112A GREAT RUSSELL STREET
LONDON WC1B 3NP

PROPOSAL: Details of cycle storage (Condition 6) of planning permission 2015/3605/P allowed at appeal ref: APP/X5210/W/16/3147078 dated 04/10/2016 for 'Change of use of part ground floor and basement levels -4 and -5 from Car Park (sui generis) to 166 bedroom hotel (Class C1), including alterations to openings, walls and fascia on ground floor elevations on Great Russell Street and Adeline Place'.

Application for planning permission reference: 2019/0226/P

22 June 2019

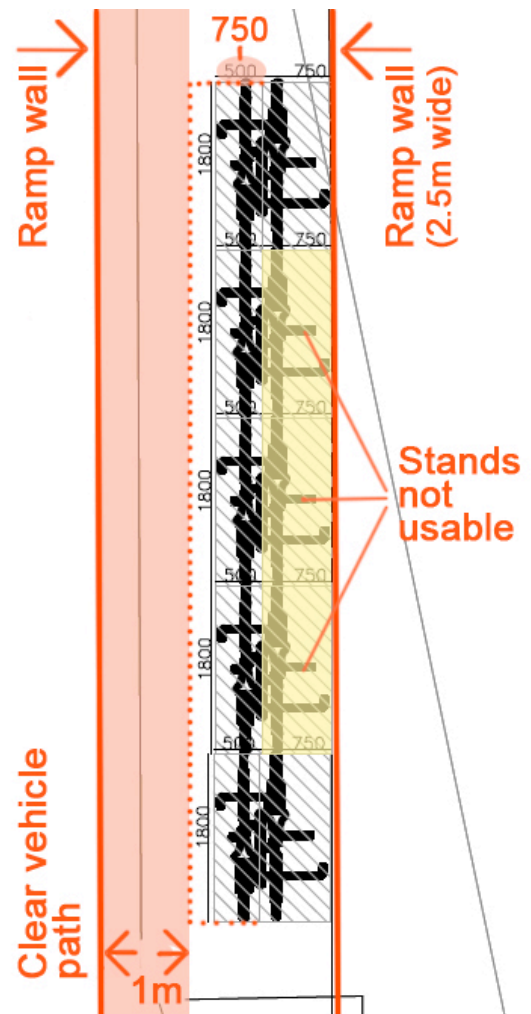
5. Drawing number 2897/P/11 revision G, Proposed Ground Floor Plan, indicates 26 visitor cycle parking spaces with Sheffield stands on the former car park exit ramp. The ramp is approximately 2.5m wide. That leaves a clear zone of 1.0m for service vehicles to move past. This is insufficient space to safely accommodate any servicing vehicle while also allowing visitors convenient and safe access to park cycles. Conversely the requirement for servicing vehicles to move past should not compromise the provision of safe cycle parking. As proposed, servicing on the ramp will prevent it also being used for cycle parking. Both uses require the same space; there is no overlap and they appear to conflict in their spatial needs.

8. Cycle parking is proposed in rows of five and two stands, parallel to the ramp wall. If the space standards given above are adhered to and the Sheffield stands positioned 750mm from the ramp wall, only those at each end of the line of five stands will be usable. There will be insufficient space relative to the ramp wall to gain access to use the inner side of the three

middle stands. Circulation aisles must be at least 1800mm in width for standard cycles (CPG item 8.40). TfL guidance recommends stands should be set a minimum distance of 900mm from the wall in similar circumstances (*Workplace Cycle Parking Guide Section 6, Diagram 6*, and *London Cycling Design Standards, Section 8.4.4, p14*). If the lesser dimension is applied, the clear zone for service vehicles to move past would reduce to 850mm.
